<h2 style="margin: 0;">External Design Document Suitability Review Checklist</h2>
---	---

Title: Site Specific PMP and Ancillary Meteorological Analysis

Number: 180461.51.1011

DOCUMENT NUMBER/ TITLE: 180461.51.1011 - PINGP Site Specific PMP and Ancillary Meteorological Analysis

Figure 14. 24-hour all-season Depth-Area curves at the PINGP basin centroid

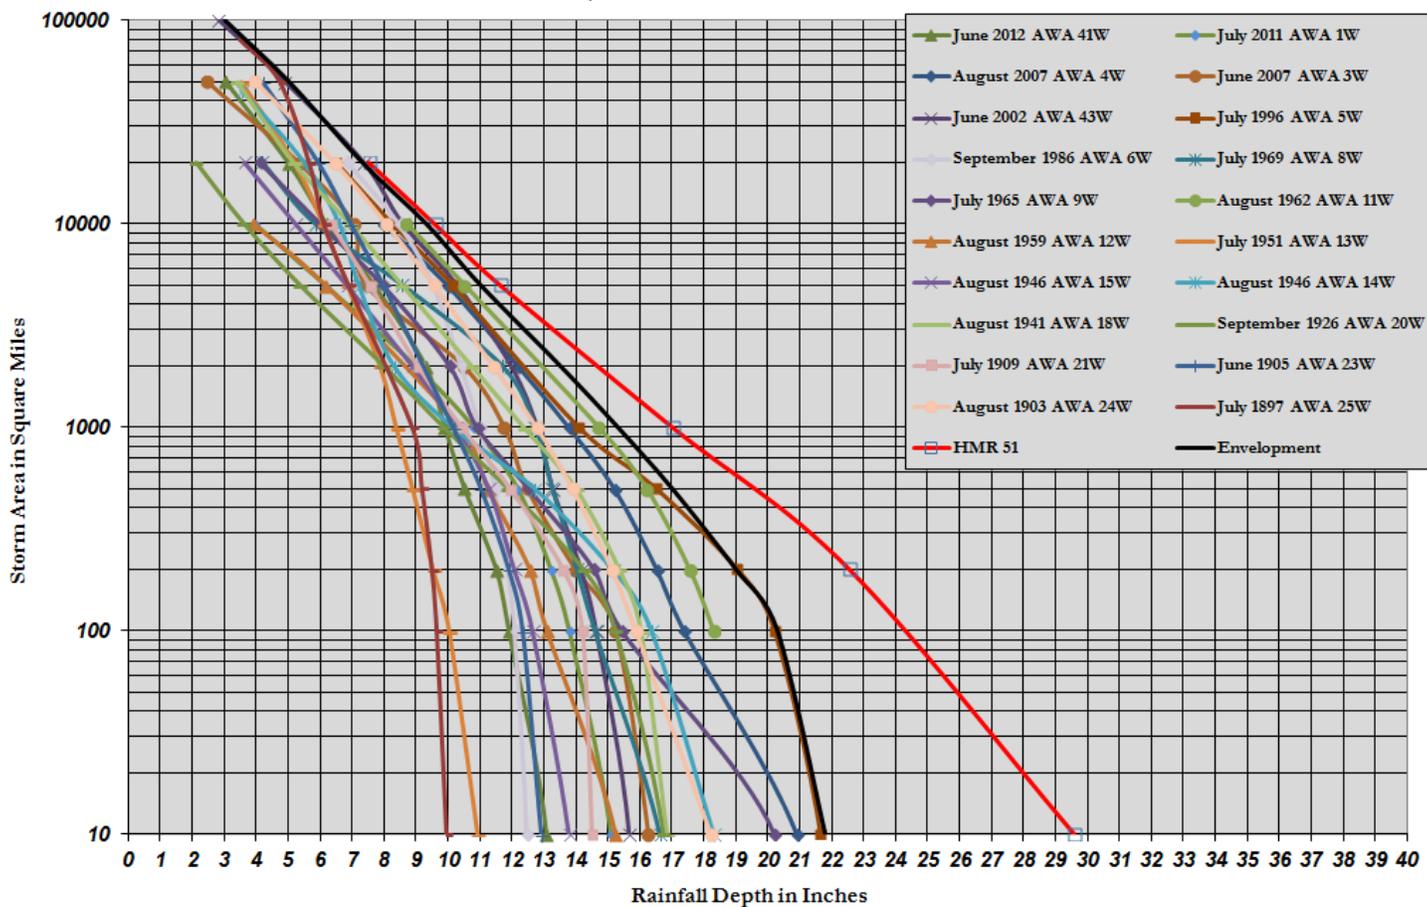
Design Review Comment Form	
11	<p>14 (and, if necessary, other parts of the calculation) with Attachment 7.</p> <p>Also regarding Figure 14 on page 45: Figure 14 still does not list Storm 22W, as Aterra noted. The storms listed in Attachment 7 do not include Storm 22W either. Please mention Storm 22W in the calculation as appropriate.</p>		
Reviewer: Bill Partridge Date: 16MAR15		Preparer:  Date: 03-16-2015
